4 March 2021

**INFORMAL REFERRAL COMMENTS – DA 090/M022/21  
12-16 GLEN OSMOND ROAD PARKSIDE**

*Construction of two, seven storey mixed use buildings with a publicly accessible central pedestrian link. Each building will comprise of; - two levels of commercial space, totalling 722 square metres; - 35 (3 x 1 bed, 29 x 2 bed and 3 x 3 bed) residential apartments and 4 townhouses; - three levels for parking purposes - 43 square metres for bin storage on ground floor; and - shared terrace area on level 2 (320.4 square metres).*

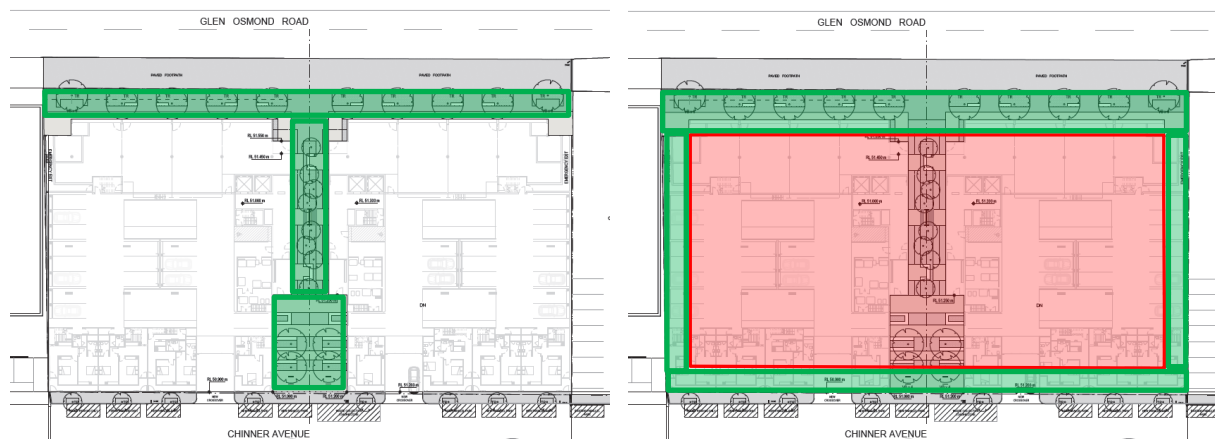
- Two stages/towers with consolidated central plaza is a positive but enlarged building footprint and reduced boundary setbacks compromise Glen Osmond Road boulevard, Chinner Avenue amenity and overall landscaped setting;

Building footprint 85% (15% green)

Max Policy footprint 75%

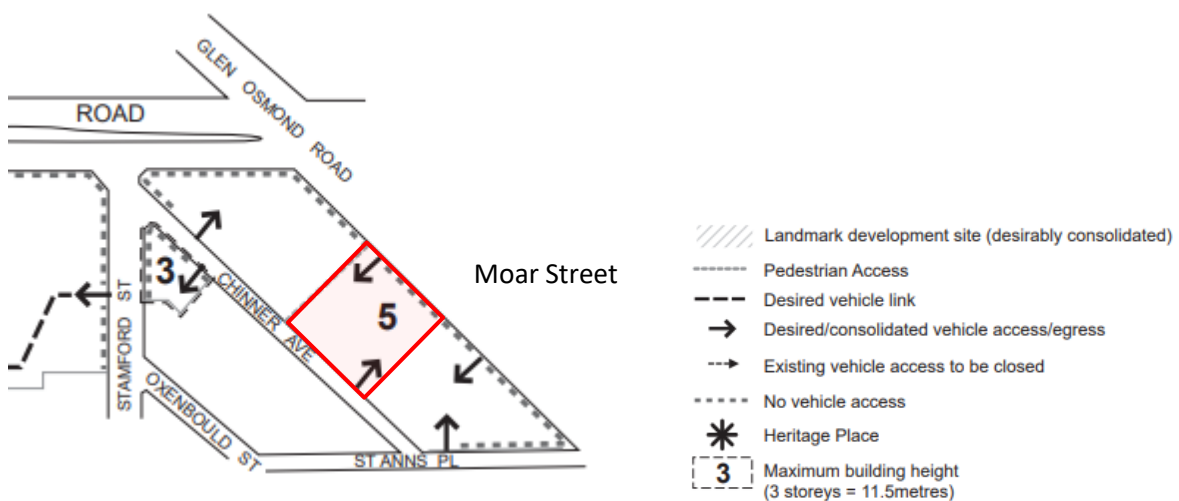
Establishment of large street trees to Glen Osmond Road is positive. Their location should be sufficiently recessed from current carriageway so that they remain as part of the new road verge and footpath into the long-term considering the proposed 4.5 metres road widening. The public bicycle racks, eg north east and south east corners, should be appropriately relocated, preferably to main pedestrian entry points and near central plaza, and all trees aligned so as to be preserved in the long-term new verge for Glen Osmond Road.
